Subject: Cinderella PS Elimination
Project Modification
IOAP Project No. S_PO_WC_PC04_M_01_C
Civil Action No. 3:05-cv-236-S
DOJ Case No. 90-5-1-1-08254

MSD is requesting approval of a proposed minor project modification to the Cinderella PS Elimination project (IOAP Project No. S_PO_WC_PC04_M_01_C). This request is part of the ongoing adaptive management review of the Integrated Overflow Abatement Plan (IOAP), approved May 2021.

2022 Project Modification Request

Cinderella PS Elimination

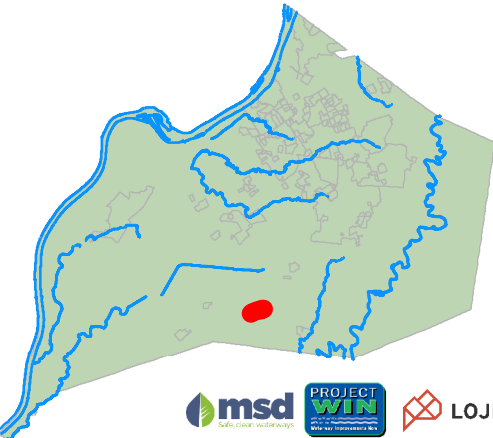
The project modification request involves changing the completion date to December 31, 2030 in order to allow for the completion of the Admiral Way Pump Station (AWPS) diversion project. This time extension provides the necessary time for easement acquisition and construction of the AWPS diversion project. The diversion project allows for the highest benefit-cost scored alternative for the mitigation of SSOs at the Cinderella PS while preventing downstream capacity issues and making Asset Management related improvements. The project technology remains a pump station elimination, although the alignment of the pump station elimination and discharge location is changed from the 2021 submittal, resulting in approximately 4,450 LF of 10" sewer. The project level of control will remain a 2-year, 3-hour storm event.

Project Name	Cinderella PS Elimination
Project Number	S_PO_WC_PC04_M_01_C
Modeled Area	Pond Creek
Branch or SSO ID	PC04
Project Type	Diversion
Receiving Stream	Fishpool Creek and Manslick Branch
Project Description	This alternative eliminates Cinderella PS by constructing 4450 LF of 10" pipe. It will require 208 LF of tunneling under I-265.
Reason for Overflow	Pump station and system capacity
Design Parameters	This solution is based on a 1.82 inch cloudburst rain event.
Project Constraints	N/A
Estimated Capital Cost	\$2,205,000
Weighted Benefit/Cost Ratio	43.86
